BIDDING AND CONTRACT DOCUMENTS
ADDENDUM NUMBER ONE
STATE PROJECT NO. 15-030C-1

DATE: JULY 19, 2016

NORTH CENTRAL MISSOURI REGIONAL AIRPORT

SUBJECT: ADDENDUM NUMBER ONE TO THE BIDDING DOCUMENTS FOR:
CONSTRUCT COMMUNITY HANGAR WITH TERMINAL BUILDING

FILE:
DESIGN BY: APB
DRAWN BY: CMT
CHECKED BY: XXX
APPROVED BY: APB
DATE: JUNE 30, 2016
JOB No: 15401-07
A-601
SHEET 30 OF 47 SHEETS

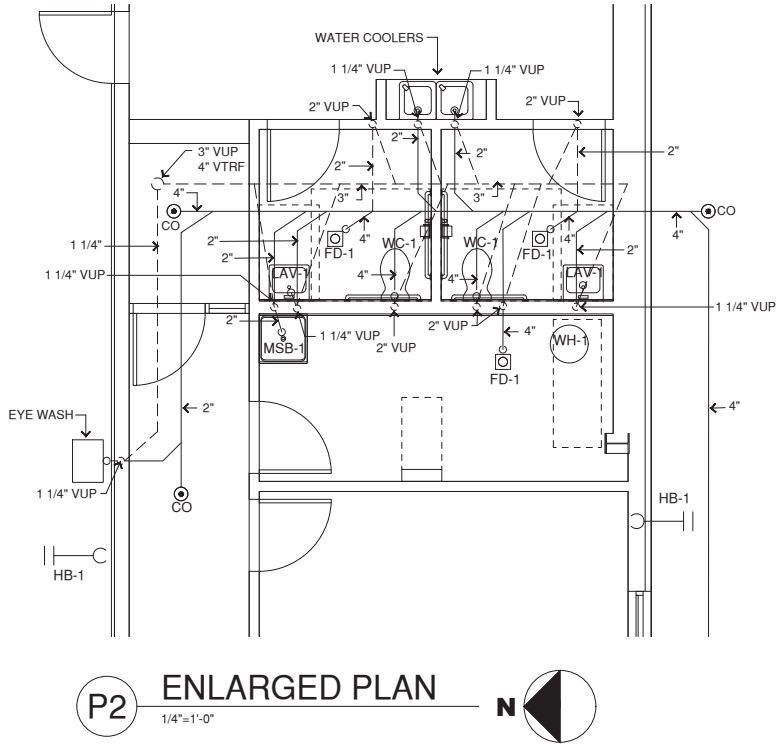
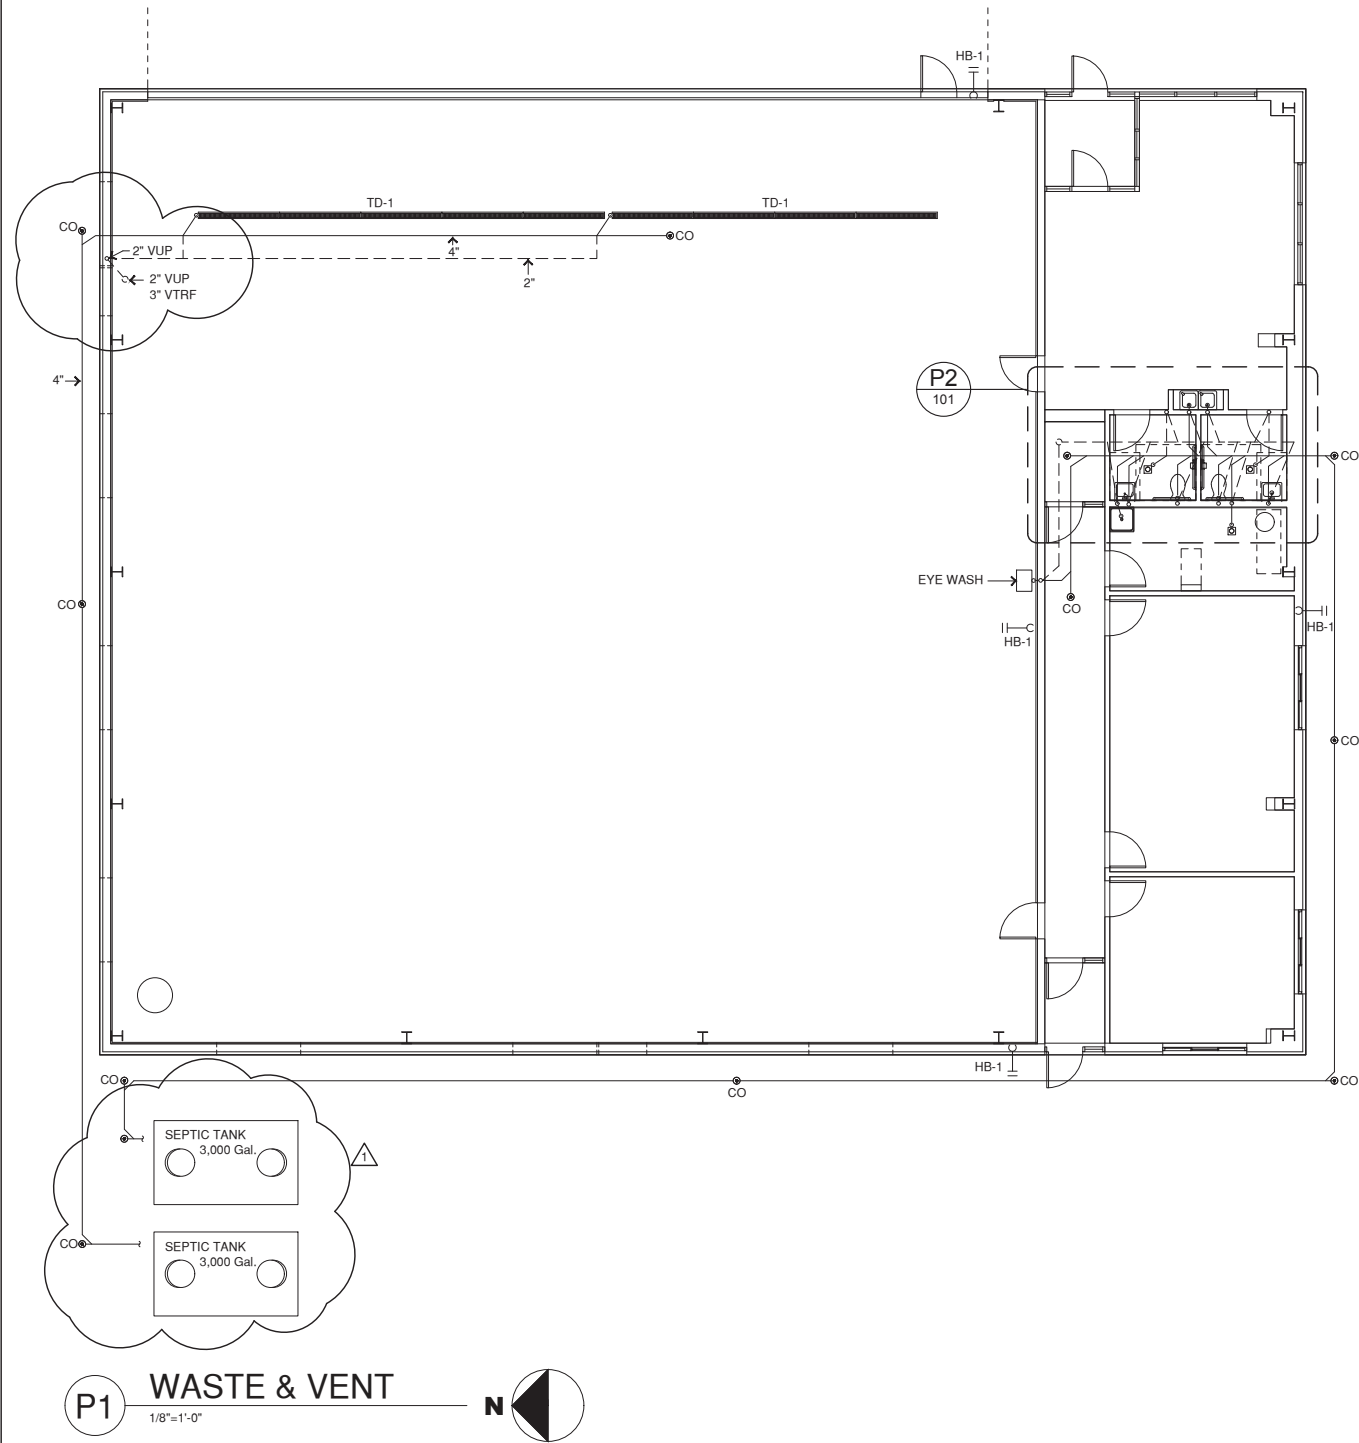
Sheet 30 of 47 (A-601)

REVISE in the MATERIAL LIST for the METAL WALL PANEL the words "HORIZONTAL APPLICATION" with "VERTICAL APPLICATION". REPLACE this sheet with Revision 1.

EXTERIOR FINISHES			
METAL WALL PANEL	900	MCELROY METAL, MEGA-RIB, VERTICAL APPLICATION COLOR: TBD	36" PANEL WIDTH
ROOF PANEL	901	MCELROY METAL, COLOR: TBD
